LIGO-T060021-01-D

Advanced LIGO

Response to Findings from the
HAM-SAS LASTI Experiment/Prototype Review

Riccardo DeSalvo, Dennis Coyne for the HAM-SAS Team

Figure 3: Predicted Passive HAM-SAS Isolation Performance at the Suspension Point of the Triple Suspension

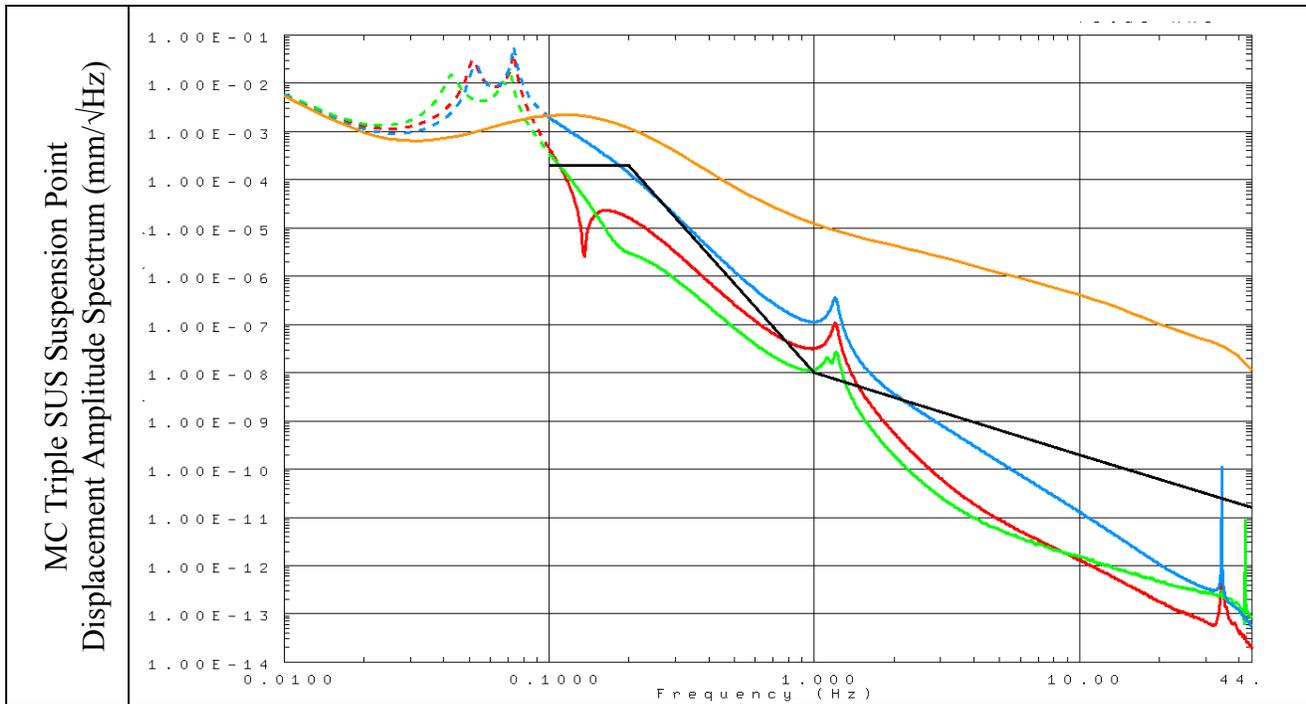
The model predicts that the isolation requirement (solid black curve in Figure 3 taken from [E990303-03](#)) is met at all frequencies, except from 0.8 to 1.5 Hz³ due to resonances at ~1.2 Hz. These resonances are predicted differential tip, tilt and yaw motions of the optics table and spring box and are a direct result of the predicted (and measured) horizontal plane stiffnesses of the spring blades. The mechanical Q of the lateral mode on a 2-blade GAS filter, with blades similar to the HAM-SAS design, was measured to be 21; this value has been used in the passive performance prediction in Figure 3. The reason for this relatively high measured loss factor, for the maraging steel blade springs, at 1 Hz is not well understood. It is not consistent with the IP maraging flexure loss factor dependence on frequency. Even if the Q was higher, some possibly active and/or passive

the exception for resonant frequencies above 30 Hz, the Q was limited to 10,000). The I-DEAS dynamic response calculation uses (equivalent) viscous damping. For the high damping factors of the IP modes, this causes an apparent $1/f$ roll off behavior (dashed curves in Figure 3). Since all previous implementations of inverted pendula show a $1/f^2$ roll off behavior⁵, and since we expect the damping mechanism to be structural (or hysteretic and frequency independent), we expect to see a $1/f^2$ roll off in the HAM-SAS design, as indicated in the solid curves of Figure 3.
